APPLICATION FOR AMENDMENT
TO
FACILITY OPERATING LICENSE NO. NPF-3
FOR
DAVIS-BESSE NUCLEAR POWER STATION
UNIT NO. 1

Technical Specification 4.4.5.2.

- A. Time Required to Implement: This change will be implemented within 30 days following NRC issuance of the License Amendment.
- B. Reason for Change (FCR No. 87-0119): Revise Technical Specification 4.4.5.2, Steam Generator Tube Sample Selection, to include a third special interest group.
- C. Safety Evaluation: See attached Safety Evaluation (Attachment No. 1).
- D. Significant Hazards Consideration: See attached Significant Hazards Consideration (Attachment No. 2).

Figure 1
 Special Interest Group Addition

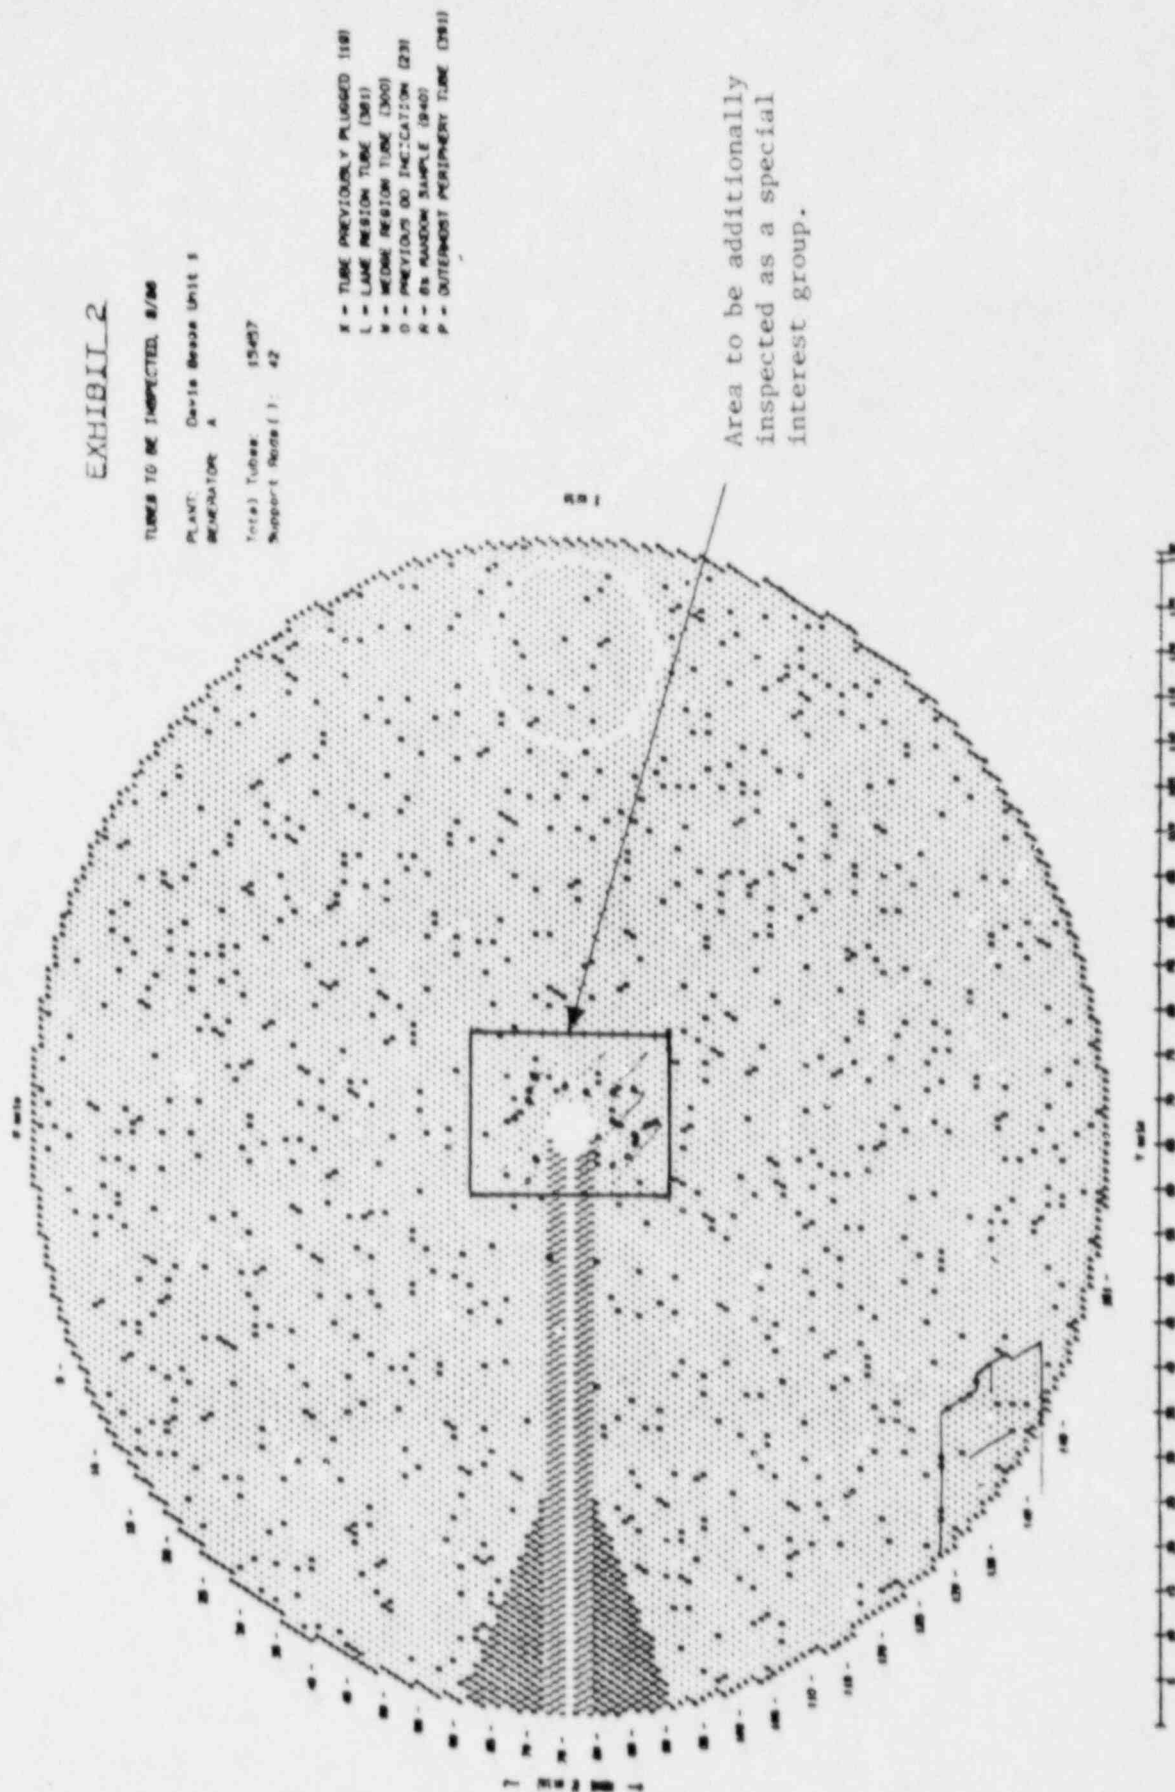
Toledo Edison proposes adding a third special interest group (A-3) under Technical Specification 4.4.5.2.b comprised of the tubes near the center of both steam generators (see Figure 1). This inspection requirement will ensure steam generator performance and provide valuable information on the condition of the tubes around the center support column.

Toledo Edison proposes adding a third special interest group (A-3), under Technical Specification 4.4.5.2.b, comprised of the tubes near the center of both steam generators (see Figure 1 of the Safety Evaluation). This inspection requirement will ensure steam generator performance and provide valuable information on the condition of the tubes around the center support column.

4.4.5.2.b (page 3/4 4-7) - Adds "3. Group A-3: Tubes included in the rectangle bounded by rows 62 and 90 and by tubes 58 and 76 excluding tubes included in Group A-1."

4.4.5.2.b (page 3/4 4-7) - Adds "3. Group A-3: Tubes included in the rectangle bounded by rows 62 and 90 and by tubes 58 and 76 excluding tubes included in Group A-1."
